SECTION 5 RESPONSES TO COMMENTS ON RECIRCULATED DRAFT REIR (FEBRUARY 2006)

Date: February 21, 2006
To: All Reviewing Agencies
From: Scott Morgan, Senior Planner
Re: SCH # 1995083033
September Ranch Subdivision Project

RECIRCULATED PORTION OF THE REVISED DRAFT ENVIRONMENTAL IMPACT REPORT (RDEIR) for the September Ranch Subdivision and Combined Development Permit located in Carmel Valley

Recirculated Portion of the Draft Revised Environmental Impact Report for the September Ranch Subdivision Project (State Clearinghouse No. 1995083033, PC 95062), County of Monterey (February 15, 2006).

Exhibit 4.9-1 Vegetation Map

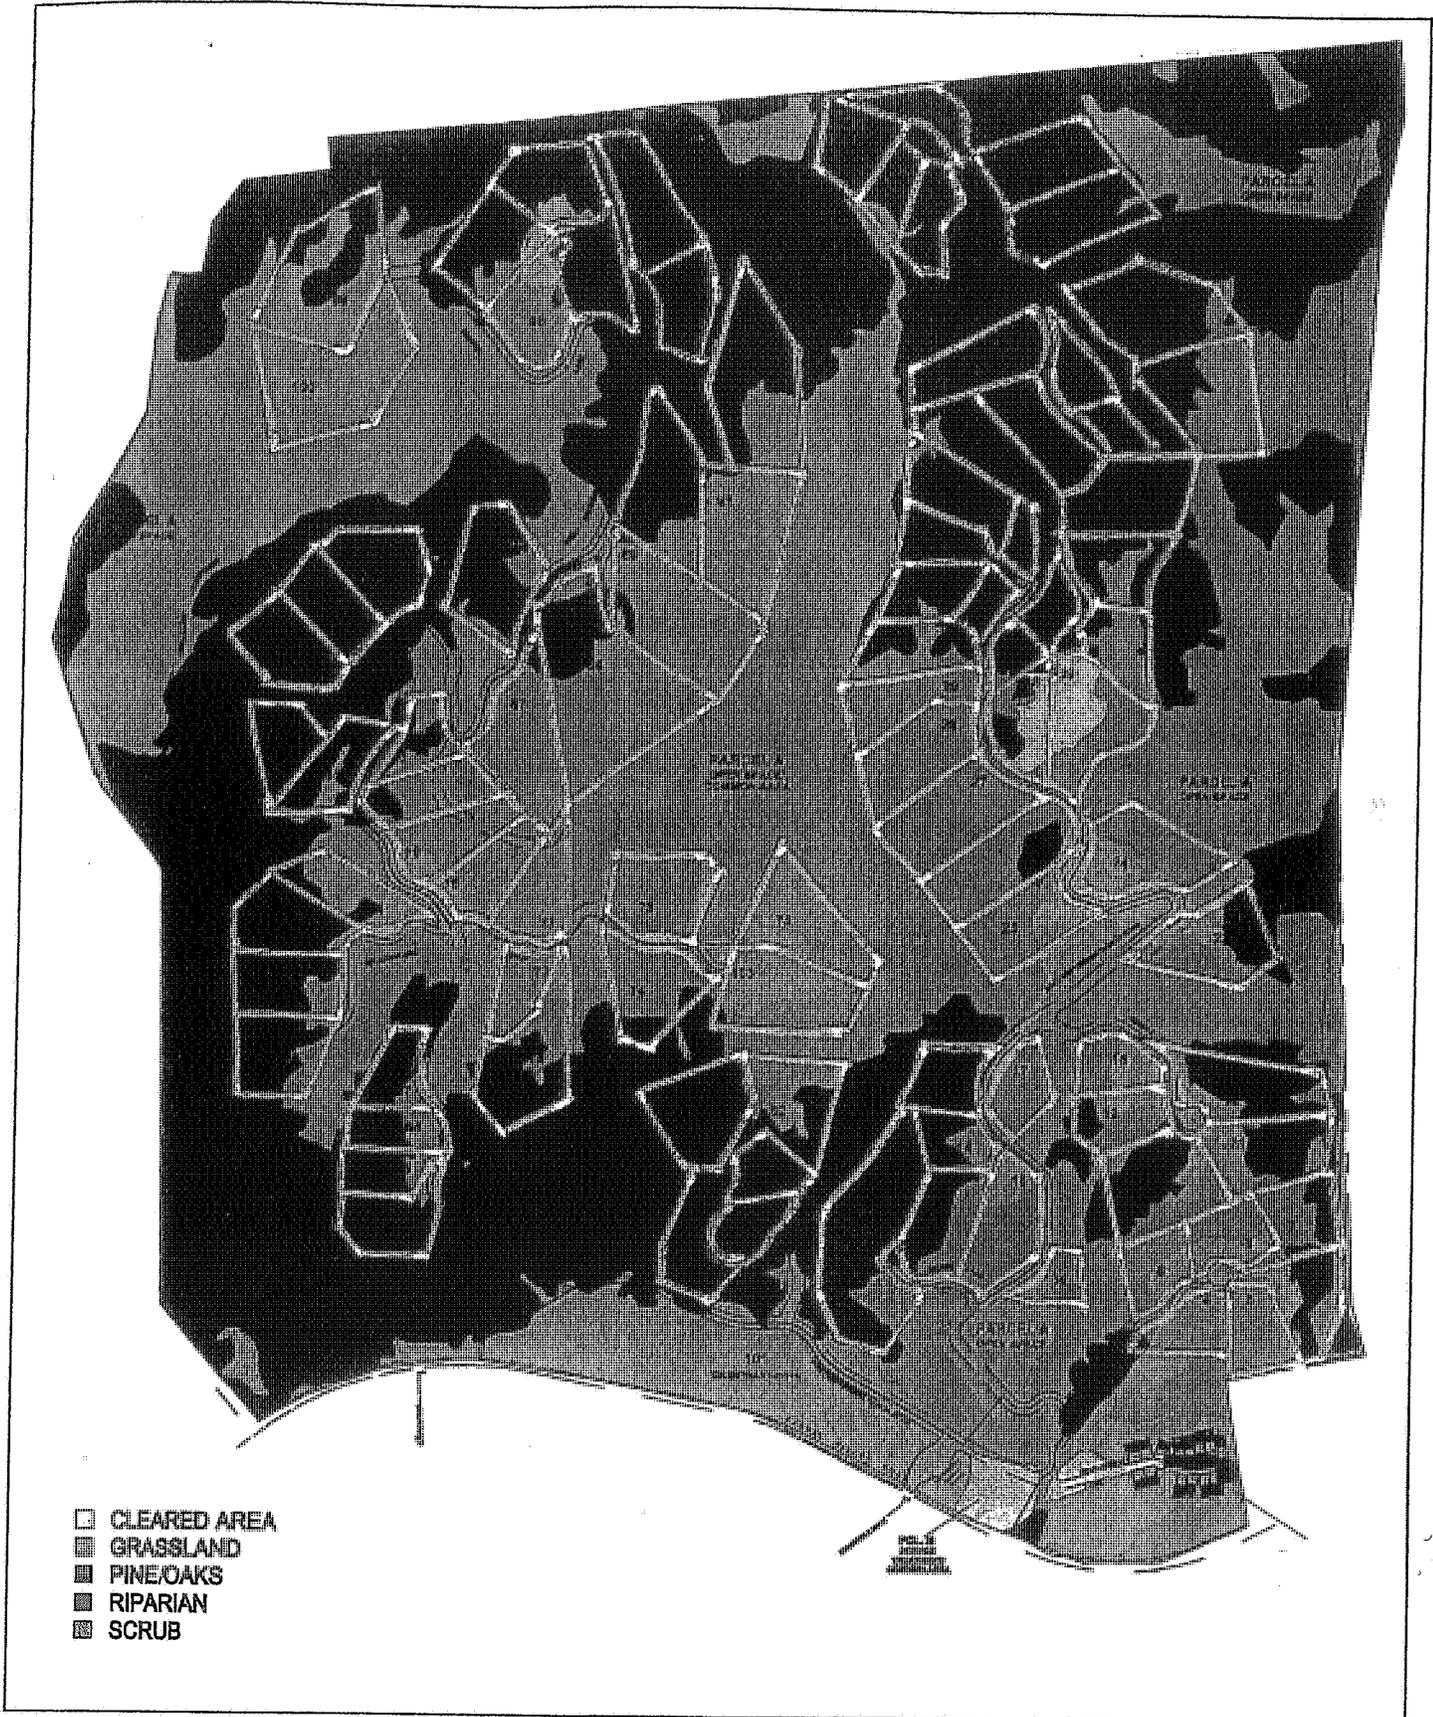
There are 62 acres of grasslands, of which 18 acres are proposed for development, according to Zander, and the RDREIR. The amount of acreage described does not appear to be consistent with Exhibit 4.9-1. Please identify the acreage of each type of land (grassland, forest, coastal scrub) by area on the map. What is meant by "development" in that statement? Does it include all the market rate residential lots in their entirety, plus the inclusionary lots in their entirety (including parking areas and other development)? Please provide a detailed breakdown of how the 18 acres was calculated.

The DREIR has addressed most of the terrestrial concerns that we expressed in our April 22, 2005 letter. A few clarifications on plant abundance and status as well as the amount of open space to be set aside (in particular Oak and Pine forest) are needed. Abundant open space has been designated on the Exhibit 4.9-1 (vegetation map) in the
